Construction Division
Additions & Alteration Charges Approval Form

Quality Control Check Report. Stage: After Finishing Stage III (Apartments)

GULMOHAR RESIDENCY

Details of Additions & Alterations

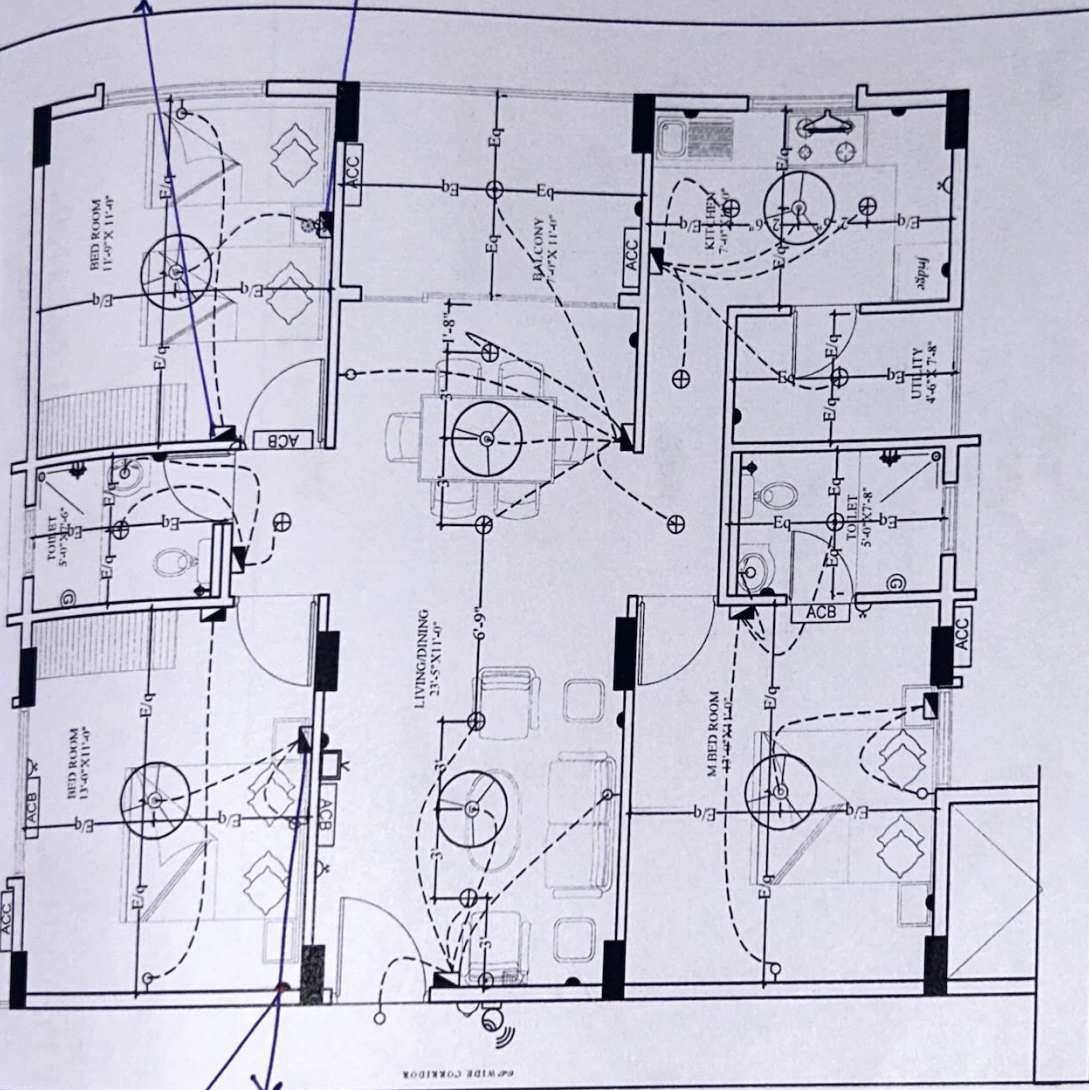
~~1~~ ① changes as in Electrical Plan

3 1/2' ht
4' ht

5amps

5amps x
15 amps

Description	Direction	Owners & Developers :	Date :	Promoted by
PLUMBING PLAN-1360 Sft (A2-TYPE)		Modi Reality Mallapur LLP	16.09.20	Modi Properties Pvt Ltd
		Project Name & Phase :	Prepared By : Jayapradha	
		Gulmohar Residency	Approved By : Soham Modi	
			Scale :	N.T.S

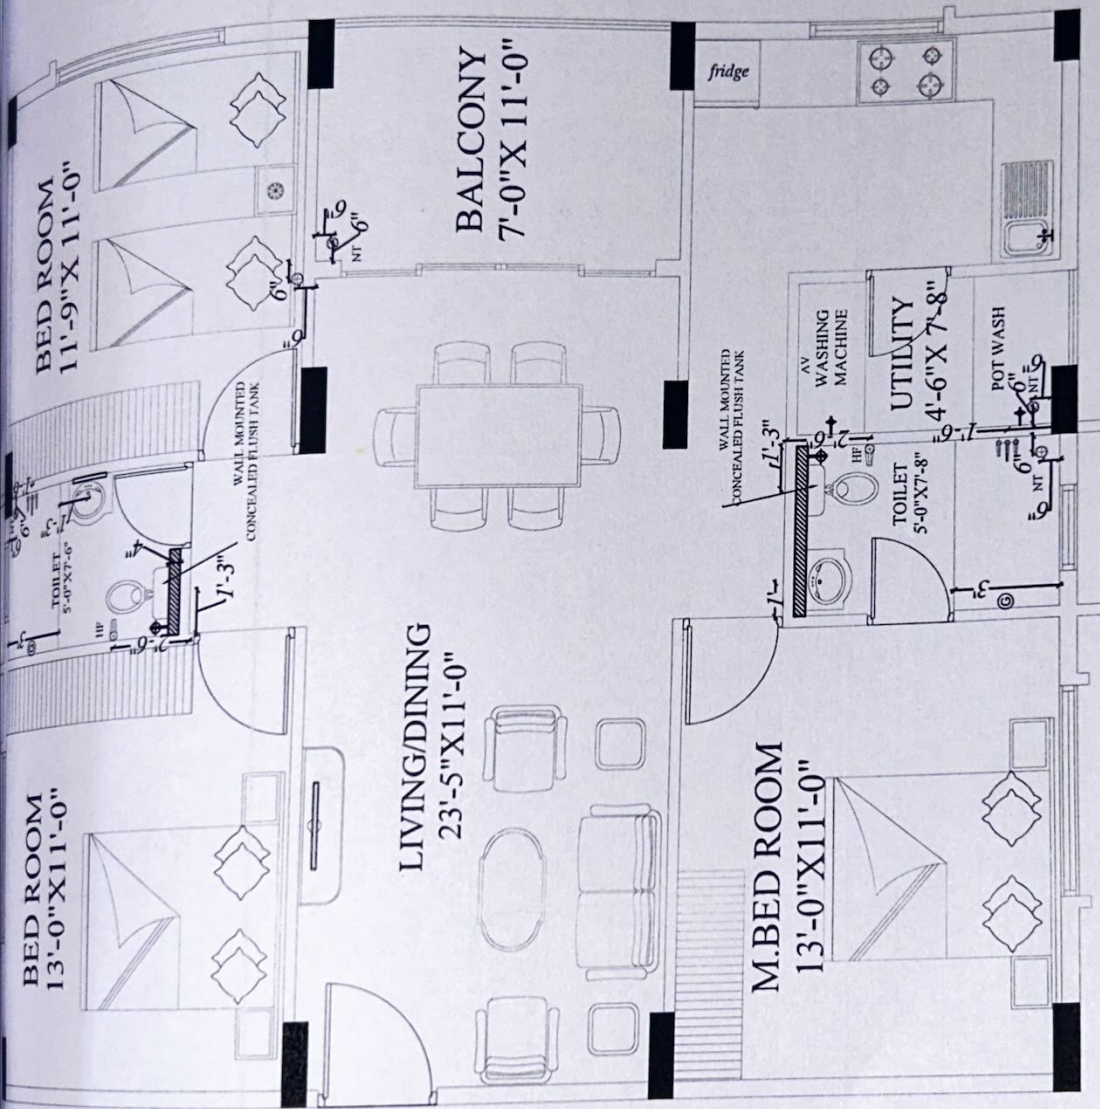
- ① W.B Point B/w. kitchen & B-R.
- ② M.T - Malaysian
- ③ C.T - ~~1~~ 1/2 tra.
